13	19.02.25	HG	Red annotations added to drawings to denote the changes made to the design as part of the NMA submission as requested by MCC.
12	11.02.25	HG	Drawing revised in line with client comments to determine levels and encapsulate all amendments for NMA submission
11	25.11.24	HG	Drawing updated as part of NMA submission and to discharge conditions
10	11.12.23	JW	Drawing package updated to show increased wall depth with 195mm reveal
9	04.12.23	JW	Boundary shown between plot 2 and 3 following planning officers comments
8	24.11.23	JW	ASHP shown indicatively, window reveal updated to show 195mm reveal and boundary updated following planning officers comments
7	14.11.23	JW	Boundary updated, ASHP labelled on plan and plot 4 carparking moved following planning officers feedback
6	08.11.23	JW	Drawings revised following planners comments on 27.10.23 and clients confirmation of updated layout
5	11.10.23	JW	Drawings updated in line with planning officer and consultant comments. T1 and T2 (trees) proposed to be retained.

CLIENT:	Jigsaw Homes and John Southworth		
PROJECT:	Lathbury Road, Manchester		
DESCRIPTION:	Proposed Street Elevations		
PURPOSE OF ISSUE:	Planning		
DRAWN BY:	CHECKED

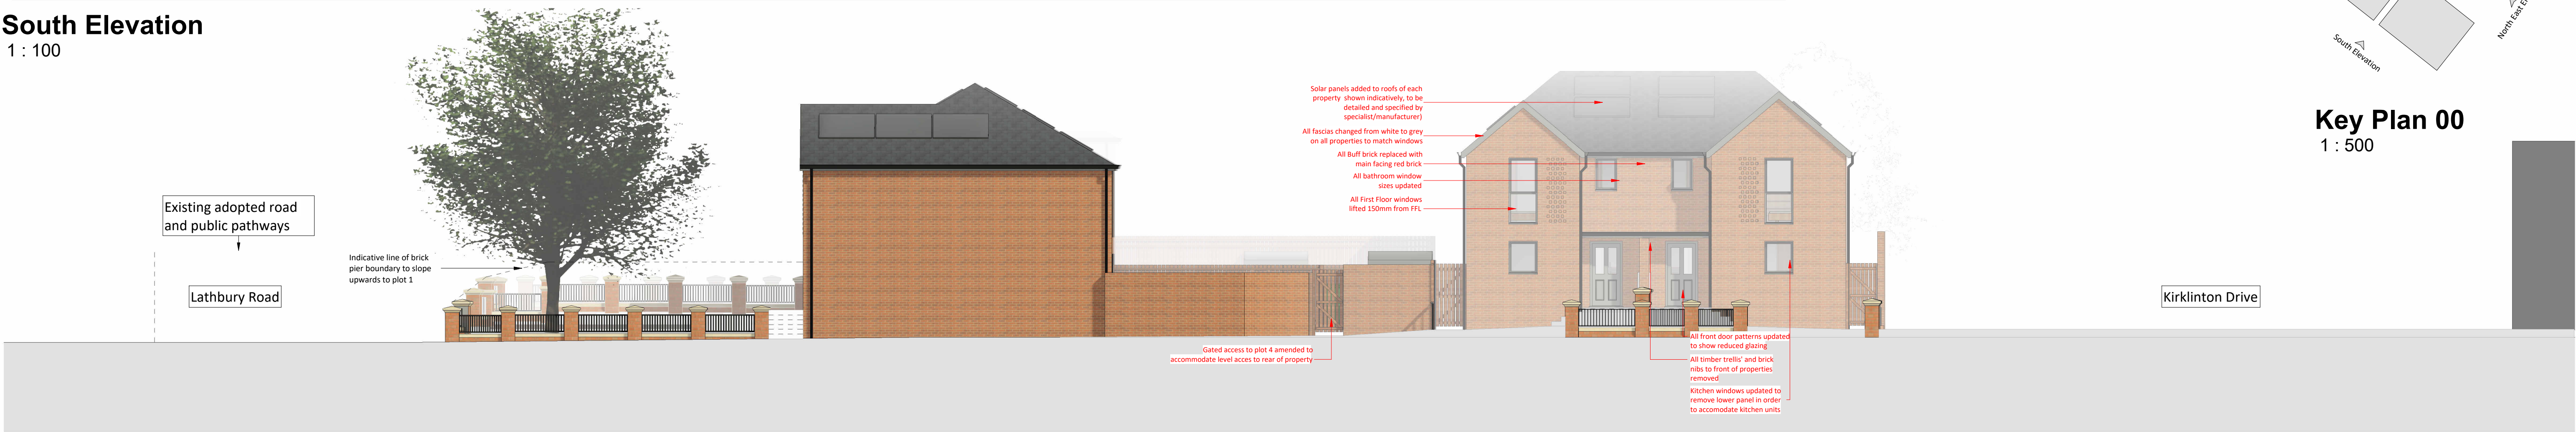
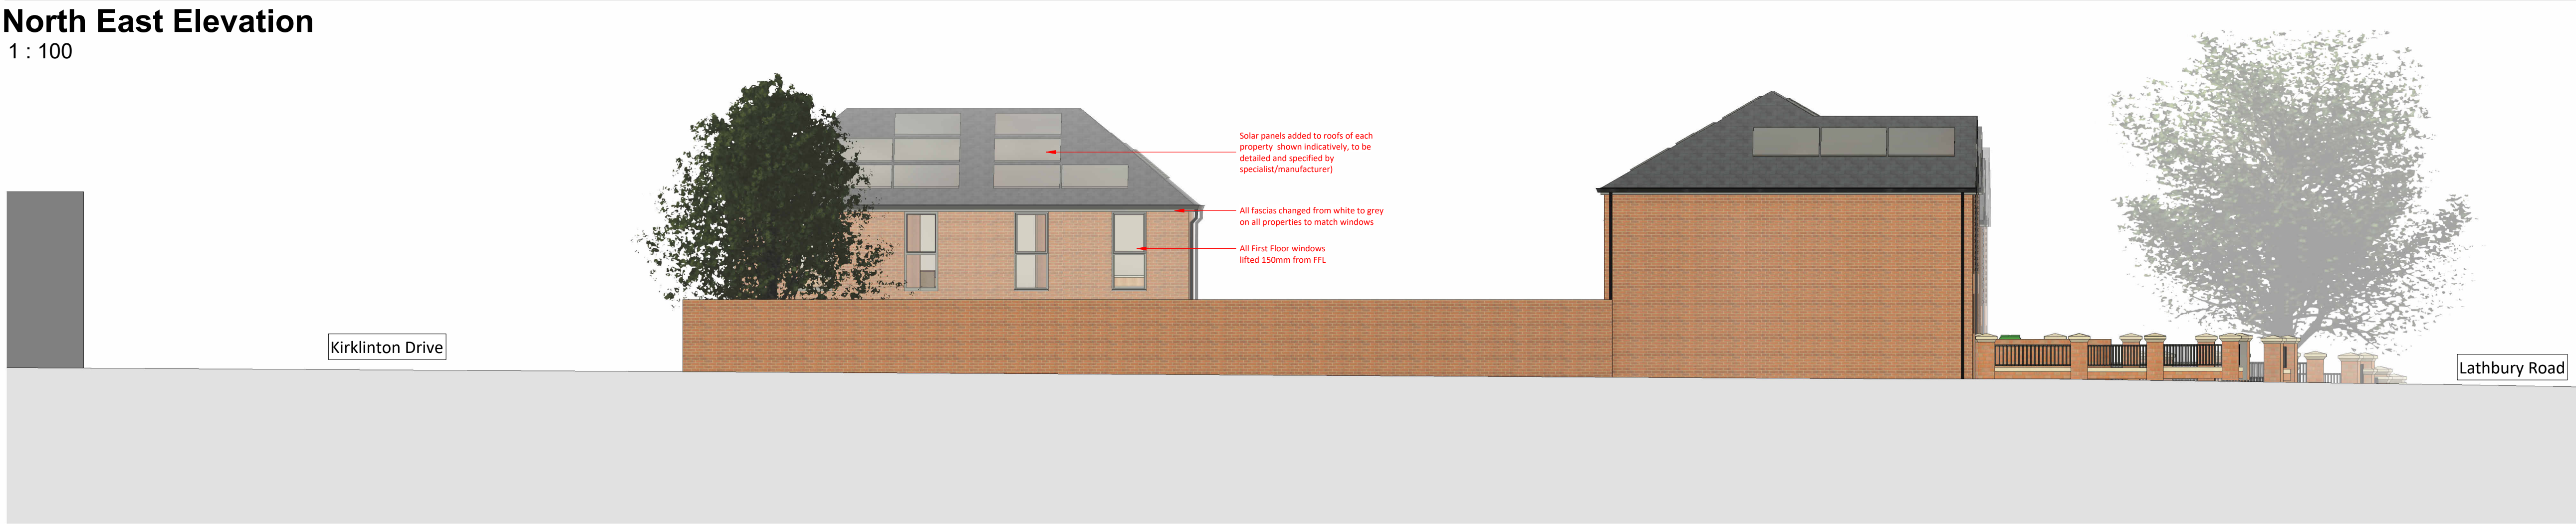
***Site levels added to planning package. Drawings amended accordingly.**
